Access Compliance Report Public Rights-of-Way (Curb Ramps)

Main Street: WICKFORD_RD		Cross Street: WELDON_HEIGHTS		Location:	NE
ADA ID: RPAT211104131909	Ramp Type: Type 4 - Parallel	Initial Pass/Fail: Fail	Overall Compliance: No	Severity Score:	15
Codes/Mitigation Info/Possible Solution			Field Measurements/Component Compliance

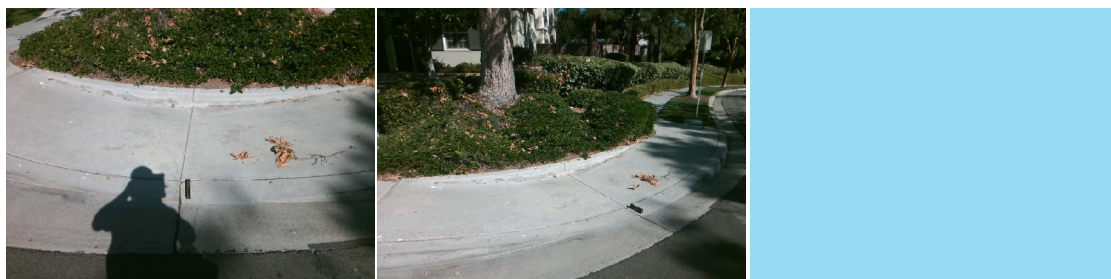
Compliance	Description	Data	Compliance	Description	Data
N/A	Ramp Length LT (in)	82	N/A	Ramp Length RT (in)	80
Yes	Ramp Width LT (in)	54	Yes	Ramp Width RT (in)	54
No	Ramp Run Slope LT (%)	9	Yes	Ramp Run Slope RT (%)	5.3
Yes	Ramp Cross Slope LT (%)	1	Yes	Ramp Cross Slope RT (%)	1.5
N/A	Landing Present	N/A	N/A	DWS Provided	N/A
N/A	Landing Length (in)	N/A	N/A	DWS Contrast	N/A
N/A	Landing Width (in)	N/A	N/A	DWS Length (in)	N/A
N/A	Landing Run Slope (%)	N/A	N/A	DWS Full Width	N/A
N/A	Landing Cross Slope (%)	N/A		DWS Offset Type	N/A
N/A	Landing Movement Obstructed?	N/A	N/A	DWS Offset Left (in)	N/A
	Landing Movement Type	N/A	N/A	DWS Offset Right (in)	N/A
N/A	Landing Shared	N/A			
N/A	Clear Space	Yes			
N/A	Clear Space To Crosswalk (in)	N/A			
N/A	Marked Crosswalk 1	No	N/A	Marked Crosswalk 2	No
	Crossing 1 Direction	W		Crossing 2 Direction	S
	Marked Crosswalk 1 Width (in)	N/A		Marked Crosswalk 2 Width (in)	N/A
N/A	Ramp Inside Crosswalk 1	N/A	N/A	Ramp Inside Crosswalk 2	N/A

Remove & Replace Curb Ramp With Two New Directional Ramps or Equivalent.
